**THE NETWORK RAIL
(ESSEX AND OTHERS
LEVEL CROSSING REDUCTION)
ORDER**

**SUPPLEMENTARY PROOF OF EVIDENCE
RELATING TO MATTERS RAISED
IN JOHN RUSSELL'S LETTER
DATED 12TH OCTOBER 2017**

Essex Stage 1 Road Safety Audit

Essex Stage 1 Road Safety Audit Response Report

Drawing No.
MMD-367516-E04-GEN-002

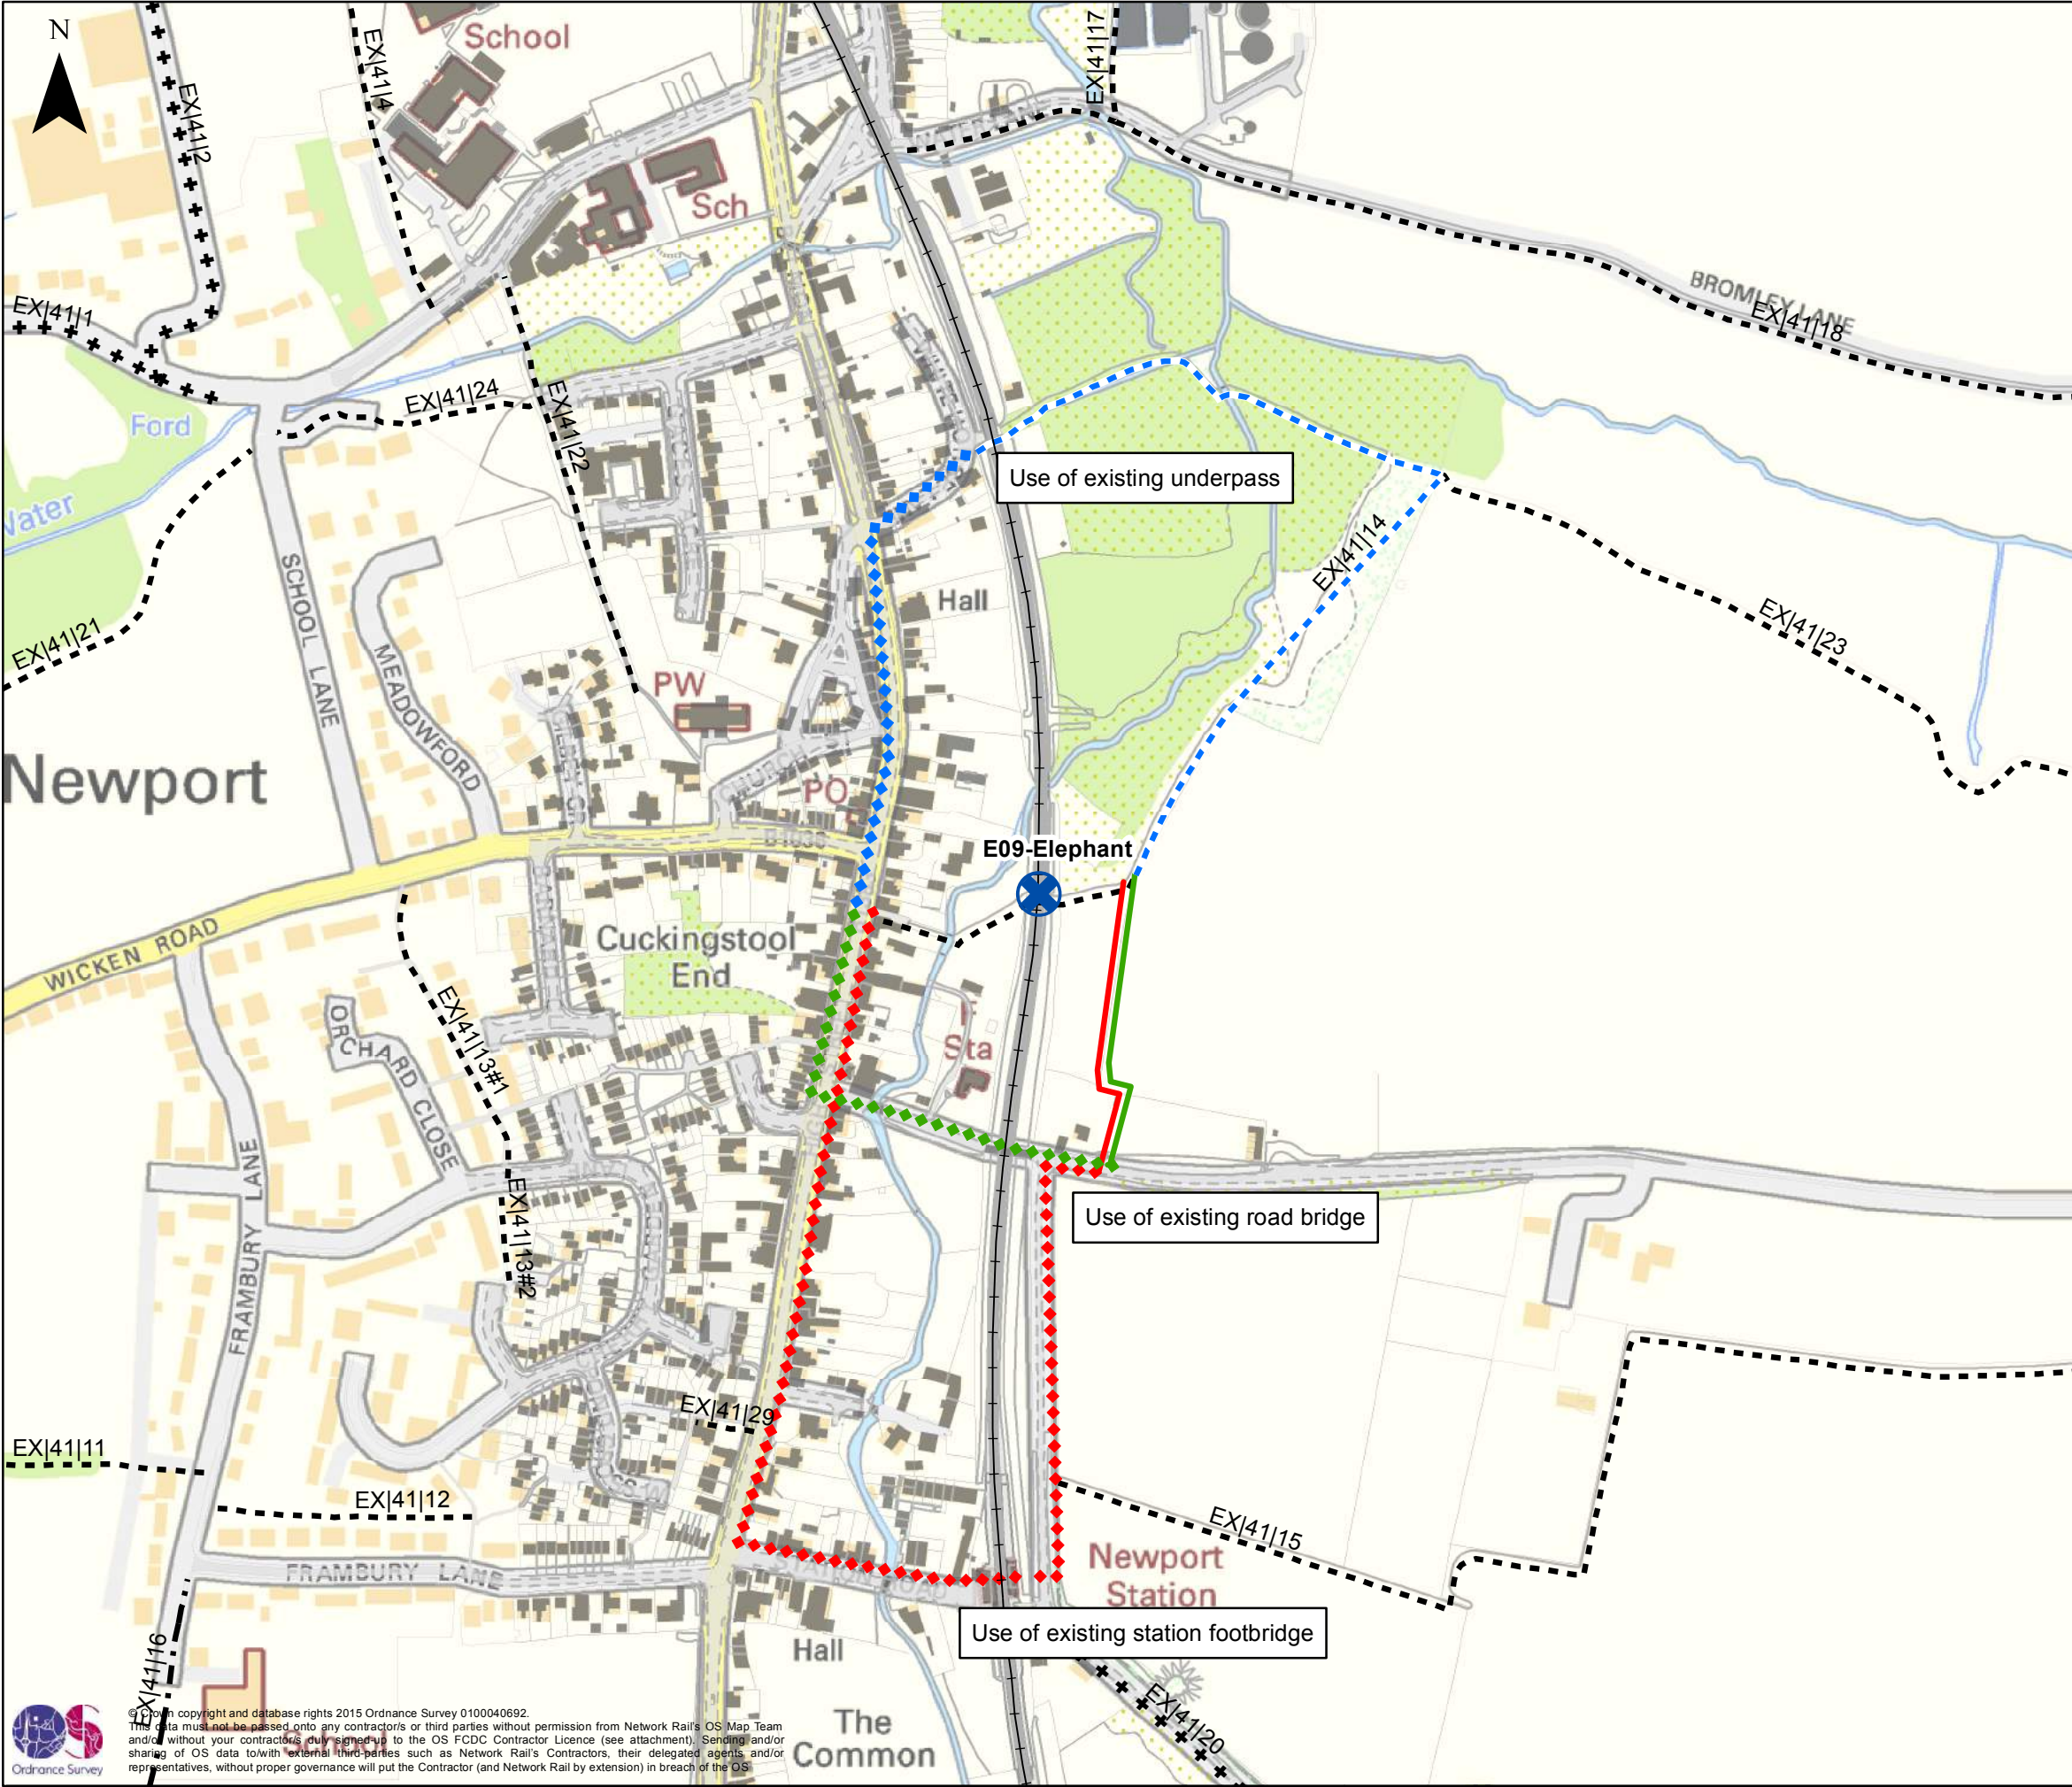
It is proposed that the alternative route will require pedestrians to cross Elizabeth Way to the southern side and continue along an existing footway. This footway crosses Herons Wood at a point where no appropriate crossing point is provided. This may result in trips or falls, or conflicts between pedestrians and vehicles. Furthermore, there is a segregated footway / cycleway along the length of the northern side of Elizabeth Way that would remove the need for pedestrians to cross any carriageways. Therefore, the proposed route unnecessarily increases the risk of collisions between crossing pedestrians and vehicles.

Design Team Response
